DOCUMENT 2009-424T

RENOVATIONS AT 7750 HURONTARIO STREET, BRAMPTON (PRP - 22 DIVISION)

ADDENDUM #6

sheet no: ADM-11

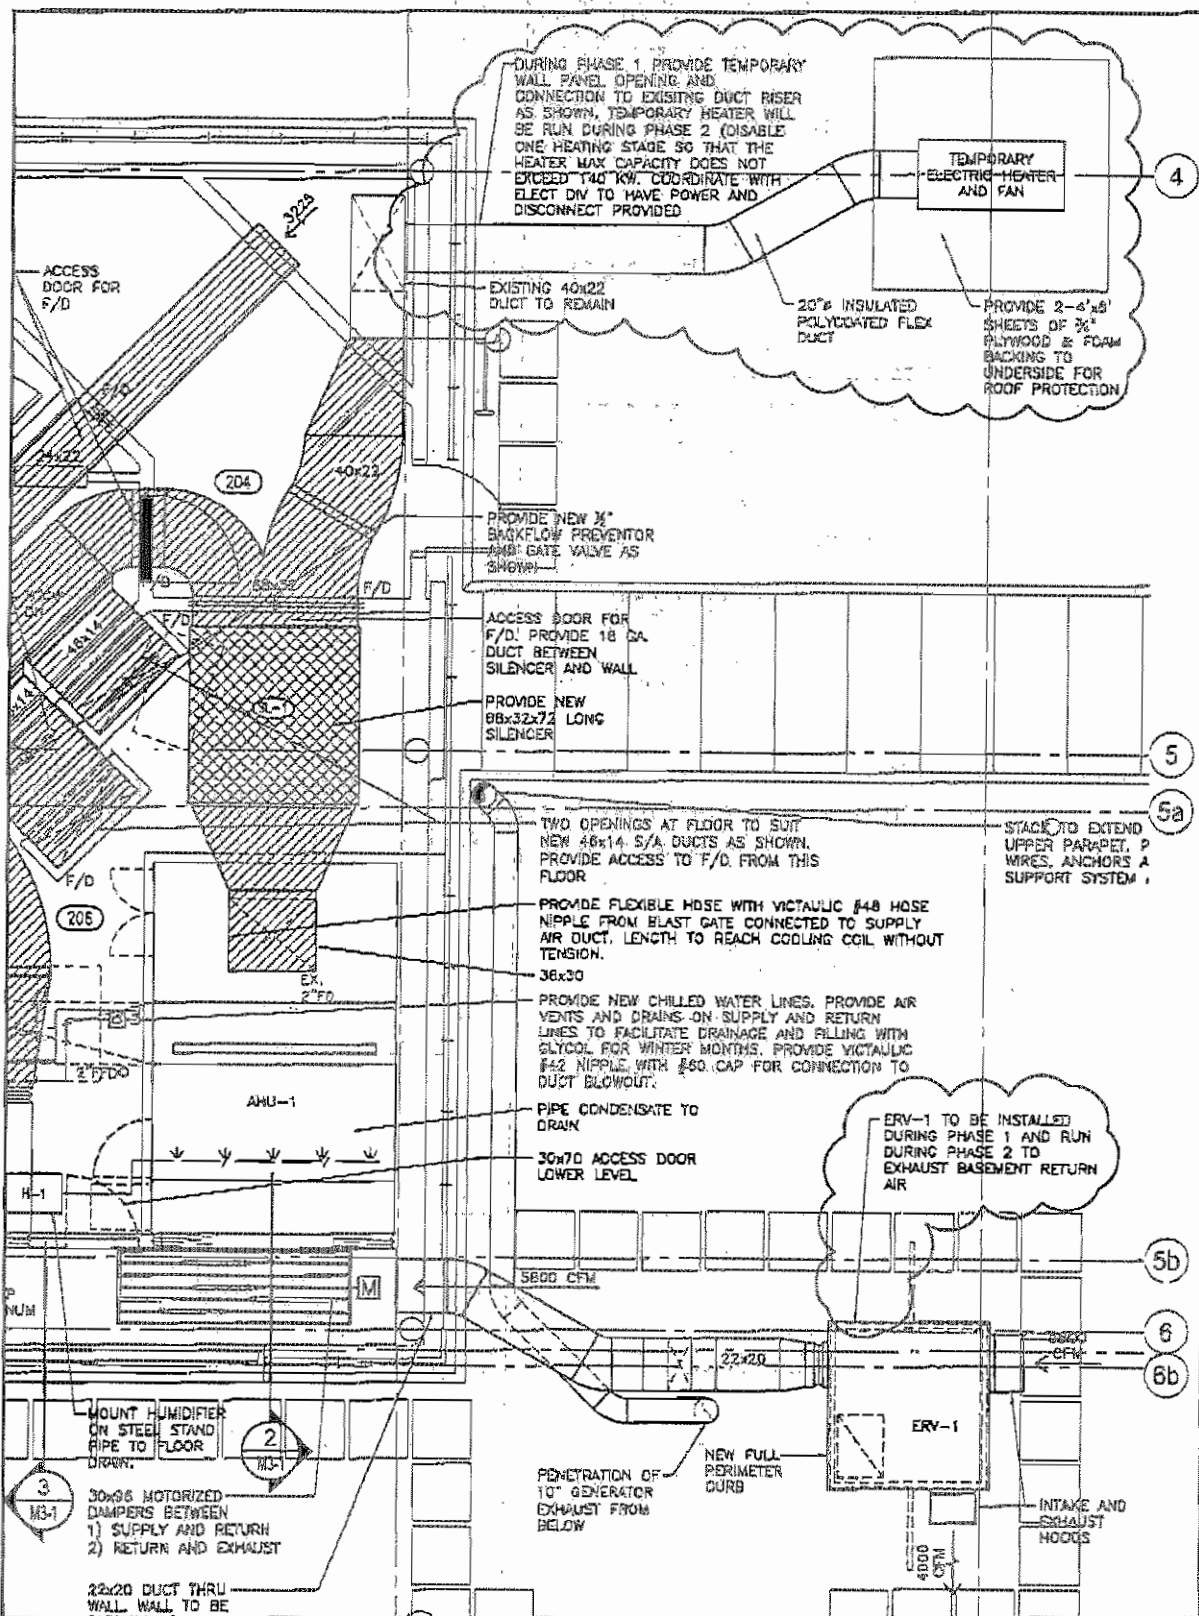
1. Refer to mechanical drawing M3-1, new Temporary Electric Construction Heater and temporary ducting is added per ADM-11 attached. This electric heater is to be installed during Phase 1 works then run during Phase 2 to provide ventilation air to the Basement Areas during all Phase 2 works. The specifications for the heater are as follows as supplied by LM Temp Control, Mississauga ph: 888-343-0914 or equal unit by Aggreko, Mississauga ph: 877-603-6021. One stage of heating is to be disabled so that the heater will not draw more than 120 KW or 140. Make wall penetration water tight.

Model LM - EI150, electric inline heater and fan, 150 KW, 600 volt, 3 phase, fan capacity of 5500 CFM @ 2" ESP, all weather construction.

2. The ERV will be installed during Phase 1, then started early in Phase 2 to exhaust return air from the Basement areas. The reheat coils in the Basement areas are to be started and commissioned during early Phase 2 work to provide zone temperature control to Basement areas.
3. Clarify phasing of work during Phase 2 for the HVAC systems as follows; during Phase 2 all the first floor HVAC systems will be replaced and also the AHU in the Penthouse will be replaced during Phase 2 whilst the Temporary Heater and ERV are run to serve the Basement Areas.

DURING PHASE 1 PROVIDE TEMPORARY WALL PANEL OPENING AND CONNECTION TO EXISTING DUCT RISER AS SHOWN. TEMPORARY HEATER WILL BE RUN DURING PHASE 2 (DISABLE ONE HEATING STAGE SO THAT THE HEATER MAX CAPACITY DOES NOT EXCEED 140 KW. COORDINATE WITH ELECT DIV TO HAVE POWER AND DISCONNECT PROVIDED)

ERV-1 TO BE INSTALLED DURING PHASE 1 AND RUN DURING PHASE 2 TO EXHAUST BASEMENT RETURN AIR
